Access Compliance Report Public Rights-of-Way (Curb Ramps)

Main Street: THISTLE_RD Cross Street: THISTLE_RD Location: NW

ADA ID: RPRK210924145808 Ramp Type: Type 6 - Directional 1 Initial Pass/Fail: Pass Overall Compliance: No Severity Score: 0

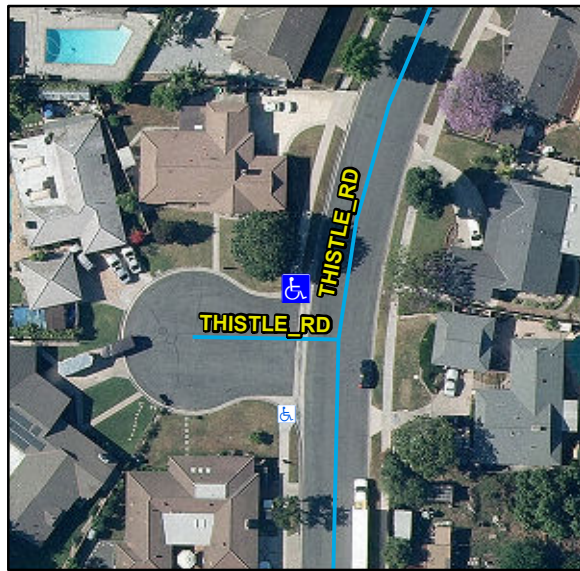
Compliance	Description	Data	Compliance	Description	Data
N/A	Ramp Length (in)	140	Yes	Flare Type LT	Curbed2
Yes	Ramp Width (in)	60			
Yes	Ramp Run Slope (%)	5.3	N/A	Flare Slope LT (%)	N/A
Yes	Ramp Cross Slope (%)	0.1	N/A	Flare Traversable LT	N/A
No	Grade Break	No	N/A	Flare Type RT	
N/A	Grade Break Slope (%)	N/A			Sloped
N/A	Grade Break Cross Slope (%)	N/A	N/A	Flare Slope RT (%)	N/A
	Addl Para Ramp Left?	No	N/A	Flare Traversable RT	No
	Addl Para Ramp Right?	No	Yes	DWS Provided	Yes
N/A	Landing Present	Yes	Yes	DWS Contrast	Yes
Yes	Landing Length (in)	100	Yes	DWS Length (in)	36
Yes	Landing Width (in)	60	Yes	DWS Full Width	Yes
Yes	Landing Run Slope (%)	0.8		DWS Offset Type	Single
Yes	Landing Cross Slope (%)	1.3	Yes	DWS Left Offset (in)	0
N/A	Landing Movement Obstructed?	No	N/A	DWS Right Offset (in)	0
	Landing Movement Type	N/A			
N/A	Landing Shared	No			
N/A	Marked Crosswalk 1	No	N/A	Clear Space	N/A
	Crossing 1 Direction	S	N/A	Clear Space To Crosswalk (in)	N/A

Remove & Replace Entire Ramp.

R304.5.2, STD 1115
